LiDAR Quality Assurance (QA) Report
Coastal New York LiDAR
NOAA Coastal Services Center
NOAA Contract: EA133C-11-CQ-0007
September 20, 2012

Prepared by:
 **Dewberry**

<p>Contract: Coastal New York LiDAR</p>	<p>Production Contractor: Photo Science, Inc.</p>	<p>Date Prepared: 9/20/2012</p>	<p>Delivery #: Area 1, Delivery 2</p>	<p>Dewberry Recommendation: Accept All Data for Priority Area 1 (Hudson River)</p>
<p style="text-align: center;">Data History:</p> <p>□ Area 1, Delivery 2</p>

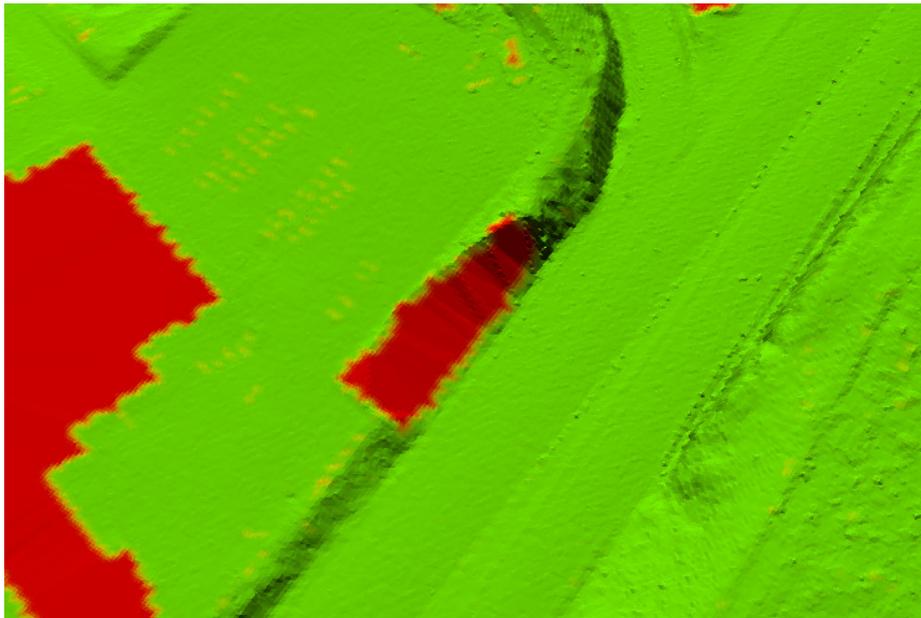
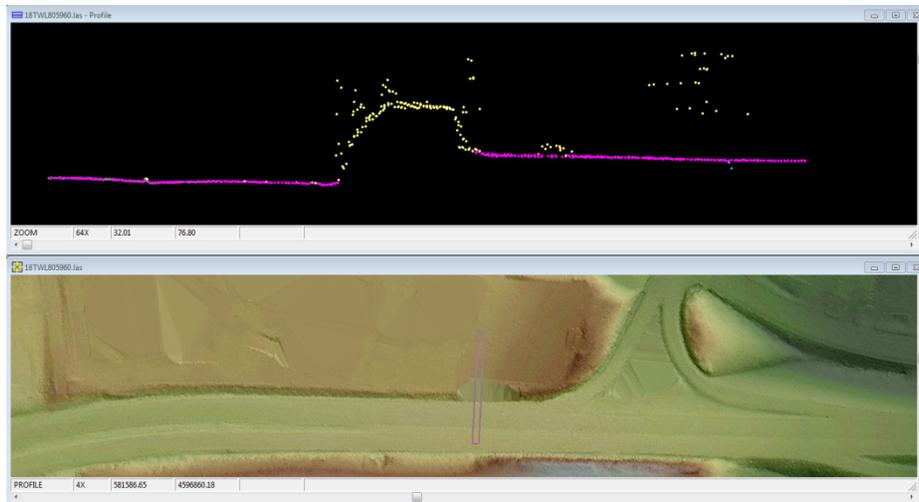
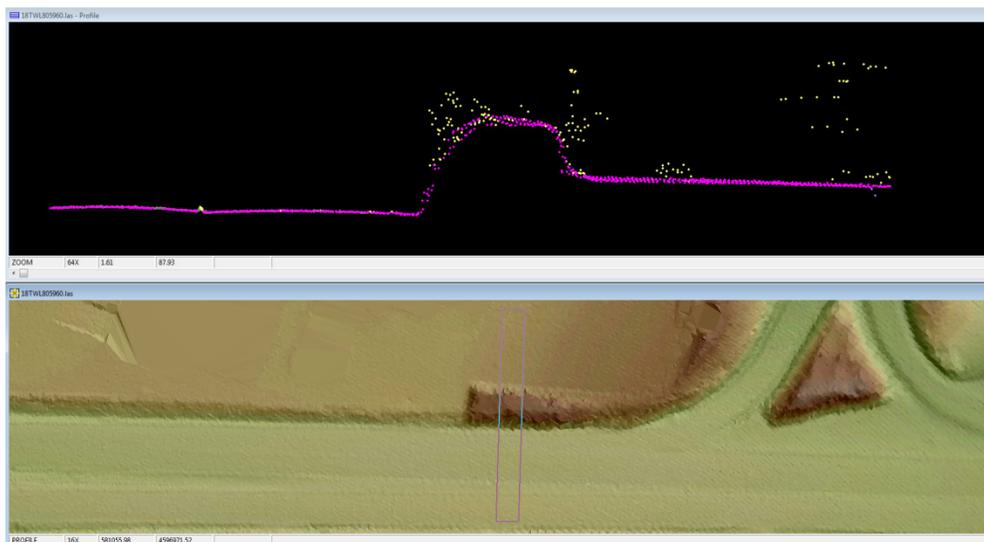
Figure 3 - Tile 18TWL805960 from the first delivery. Ground density model shows a hillside where ground points that have been removed from the ground model are colored red. Buildings and hydrographic features are expected to appear red, but red along embankments identify areas of possible aggressive misclassification.

Figure 4 - 18TWL805960 from the first delivery. Profile view of LAS cloud colored by classification is shown on top while bare-earth TIN colored by elevation is shown on bottom. This image shows that there are legitimate class 1 (yellow) points that could be reclassified to class 2 (purple), in order to improve the definition of the bare-earth surface.

Figure 5 - 18TWL805960 from the second delivery. Profile view of LAS cloud colored by classification is shown on top while bare-earth TIN colored by elevation is shown on bottom. Class 1 (yellow) points have been correctly reclassified to class 2 (purple).

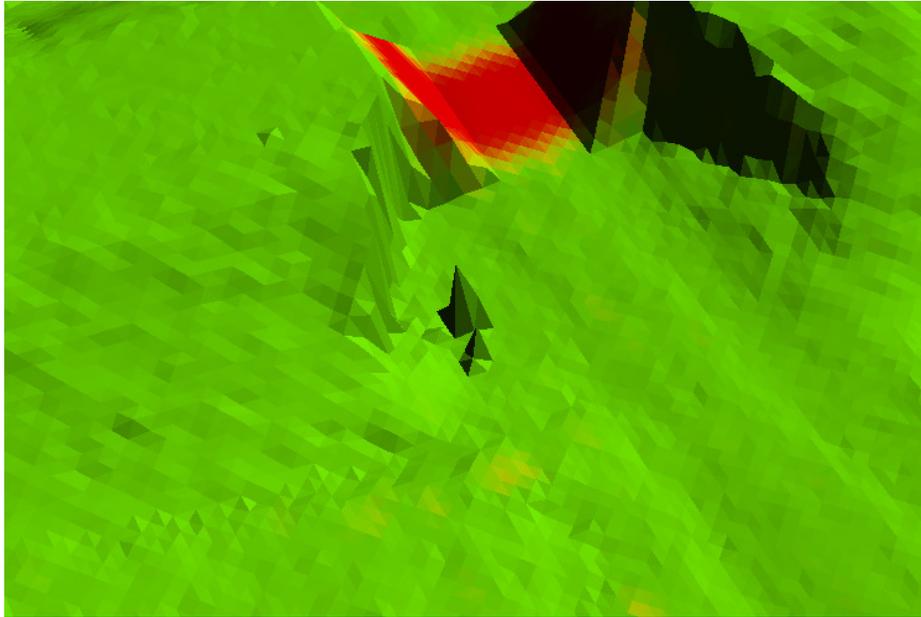
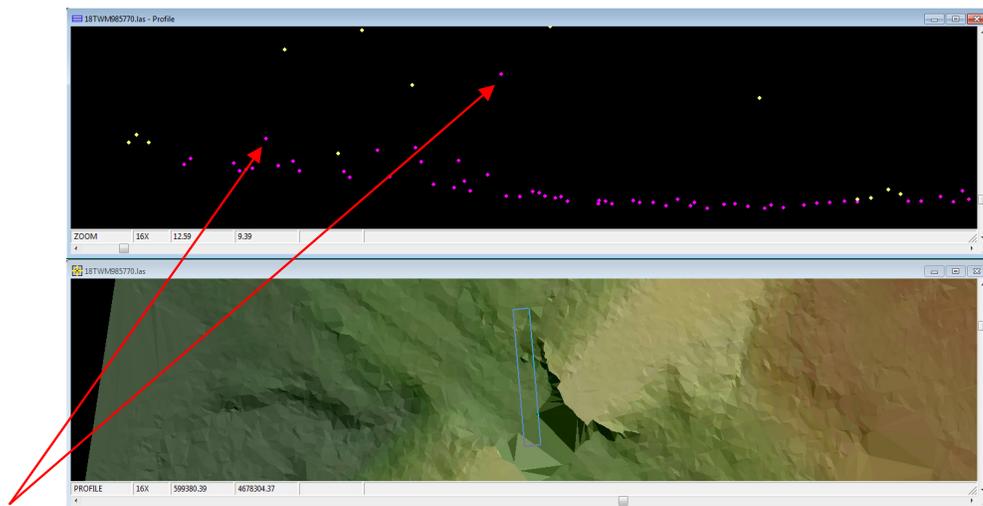
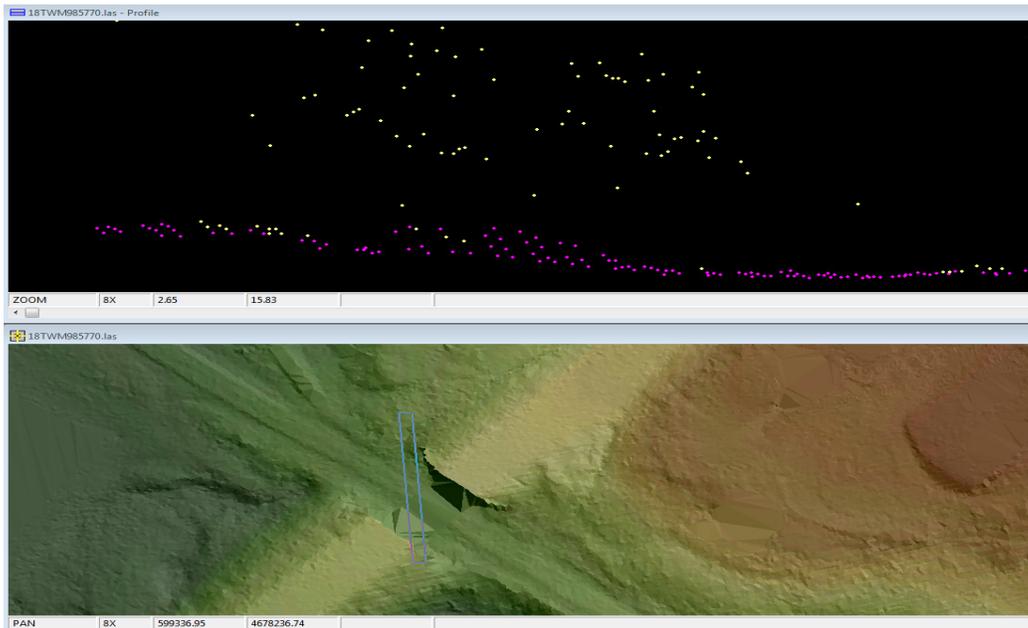
Figure 6 - Tile 18TWM985770 from the first delivery. Ground density model showing vegetation artifacts that were left in the ground model appear as spikes in the surface.

Figure 7 - Tile 18TWM985770 from the first delivery. Profile view of the LAS cloud colored by classification is shown on top while bare-earth TIN colored by elevation is shown on bottom. High ground points (purple), up to 3 meters above the true ground surface, should be reclassified to unclassified (class 1).

Figure 8 - Tile 18TWM985770 from the second delivery. Profile view of the LAS cloud colored by classification is shown on top while bare-earth TIN colored by elevation is shown on bottom. High ground points were correctly reclassified to unclassified (class 1).

Figure 18 – DEM Tile 18TXM000770 from the second delivery. Island has been removed from stream breakline (blue) and corresponding DEM has been updated to show the island in the ground model.

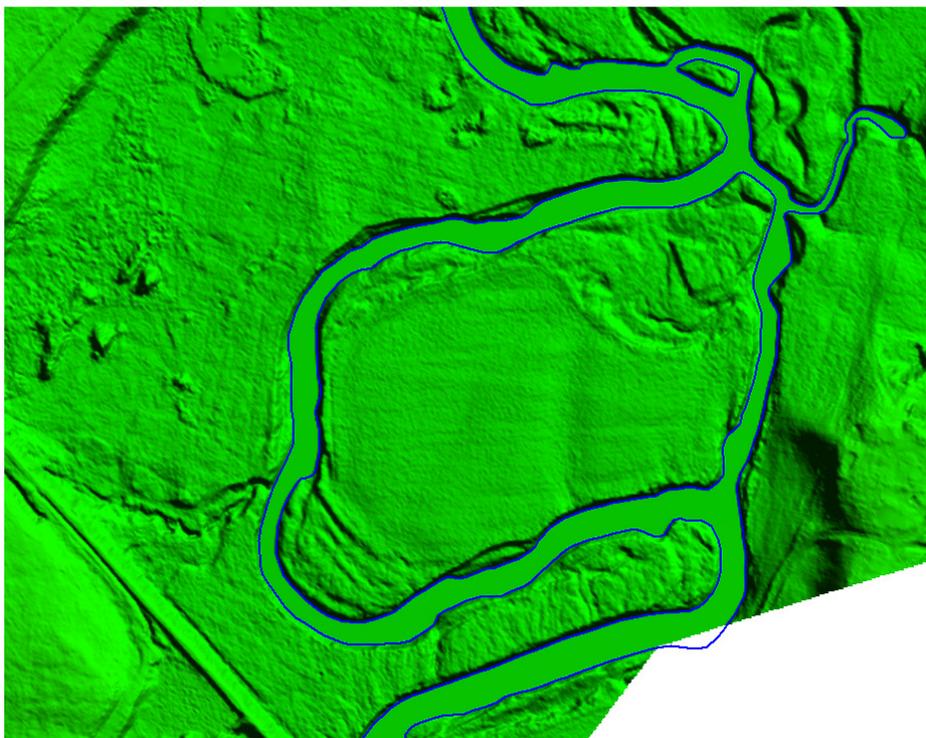
Figure 17 - Tile 18TXM015770 from the first delivery. Stream breaklines (light blue) are overlaid on the full point cloud intensity imagery. This 8 acre island should be removed from the stream breakline and can be represented with a "hole".
